Hirose Electric Co. Ltd.
5-23. Osaki 5-chome, Shinagawa-ku, Tokyo

Change of packaging specification

Notification of change to the product and request for approval

Before the change
Packed in polyethylene bags

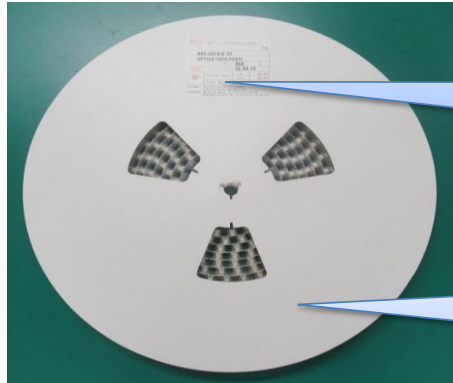
The reel was packed in a polyethylene bag containing silica gel. Only the product label was attached to the reel. Paper was used for the emboss reel.

The reel is placed in an aluminum bag containing silica gel and deaerated and packed. Since the aluminum bag is not transparent and its contents cannot be identified the product label and caution label are also attached to the packaging bag. A product label is attached to the reel. Emboss reel will be changed to a PS plastic reel.

After the change
Aluminum bag and deaeration packaging

The reel is packed in an aluminum bag (non-transparent) and deaeration packaging
